PHAP13-00023

Date: October 21, 2013
Application Type: Certificate of Appropriateness
Property Owner: Tracy J. Reyes
Representative: Tracy J. Reyes
Legal Description: 2 Radford Terrace Lot 16 (6108.79 sq. ft.), City of El Paso, El Paso County, Texas
Historic District: Austin Terrace
Location: 4625 King Arthur Court
Representative District: #2
Existing Zoning: R-4/H (Residential/Historic)
Year Built: 1997
Historic Status: Non-contributing
Request: Certificate of Appropriateness for the enclosure of the front porch at the main façade after-the-fact.
Application Filed: 09/09/2013
45 Day Expiration: 10/24/2013

ITEM #1

PROPOSED ELEVATION

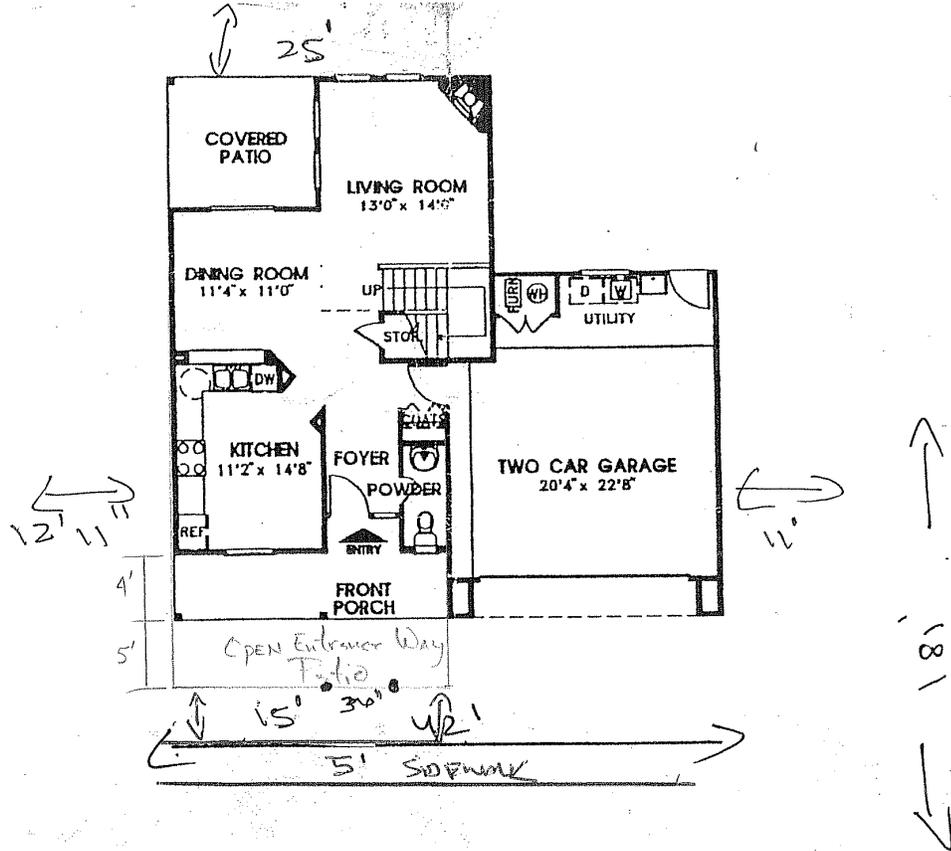
Certificate of Appropriateness for the enclosure of the front porch at the main façade after-the-fact.

The Historic Preservation Office recommends DENIAL of the proposed scope of work based on the following recommendations:

- *Porches are functional as well as decorative features that help to define the overall character of a building. Many buildings feature porches, which are one of the most common architectural features. A porch and all of its architectural elements should be maintained and repaired.*

- *Doors and windows are considered important character-defining features because of significant detailing.*
- *Retain and preserve the pattern, arrangement, and dimensions of door and window openings on principal elevations. Often the placement of doors and windows is an indicator of a particular architectural style, and therefore contributes to the building's significance. Doors and windows for new construction and additions should be compatible in proportion, location, shape, pattern, size, and details to existing units.*

- *New construction should utilize doors and windows of compatible size, style, and material in an appropriate pattern so as not to detract from the historical significance of the existing building.*

- *New additions, exterior alterations, or related new construction will not destroy historic materials, features, and spatial relationships that characterize the property. The new work shall be differentiated from the old and will be compatible with the historic materials, features, size, scale and proportion, and massing to protect the integrity of the property and its environment.*
